Board of Adjustment

Staff Report

CASE NUMBER: BOA17-00210
LOCATION/ADDRESS: The 10700 to 10800 blocks of East Southern Avenue (south side) and the 1200 through 1300 blocks of South Signal Butte Road (west side)
COUNCIL DISTRICT: District 6
STAFF PLANNER: Kim Steadman, RA – Senior Planner
OWNER: DD/Mountain Vista, LLC
APPLICANT: EARL, CURLEY & LAGARDE, P. C.

REQUEST: *Requesting a Special Use Permit (SUP) for a Comprehensive Sign Plan (CSP) for Mountain Vista Marketplace in the LC-PAD Zoning District.*

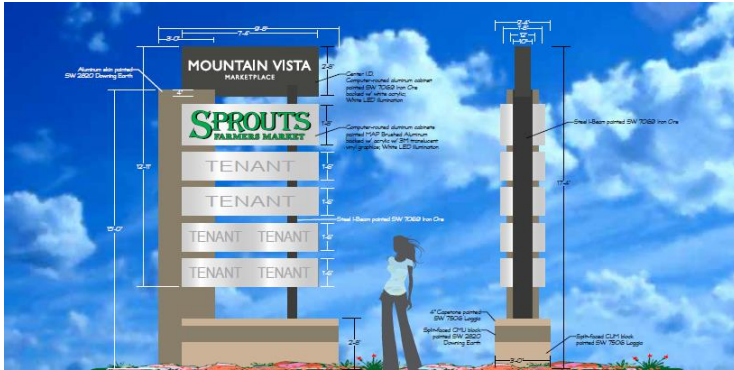
MZO caps the height of detached signs at 12', and the area at 80'. Code allows another 2' in height for architectural embellishment of the sign. An example of this is the detached sign across Southern Avenue from the subject site. The overall height of the structure (street view image, right) is 14', with 12' to top of sign. The applicant proposes a 17' tall sign across the street from this sign.

The proposed signs have a more vertical, fin-like form, with less embellishment than this sign, but there is nothing about the subject site that requires the signs to be 5'-4" taller than adjacent signs. Staff finds no justification for the applicant's proposal of detached signage that exceeds Code by 5'-4" in height, and 15 SF in area.

1. *Compliance with the sign plan submitted, except as modified by the conditions listed below.*
2. *Compliance with all requirements of the Development Services Division in the issuance of sign permits.*
3. ***Compliance with the conditions of approved of Design Review, DRB17-00044.***
4. ***The three monument signs (sign "E") are limited to 12' to top of signage, and 80 SF of sign area.***

This sign is labeled 17'-4" tall.

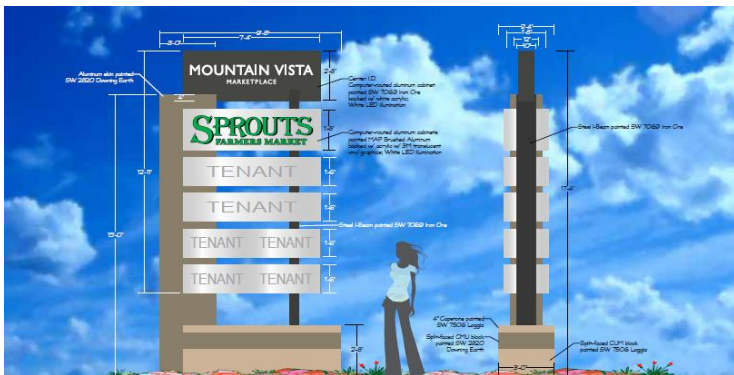
The applicant's first submittal proposed 13'-8"-tall detached signs, with a sign area of 58.4 SF. The applicant followed by proposing an even larger sign at 17'-4" tall, and 94.72 SF in area. The dimensions were changed, but the illustrations appear to be the same, making it impossible to determine the real effect of the revised sign.

This sign is labeled 13'-8" tall.
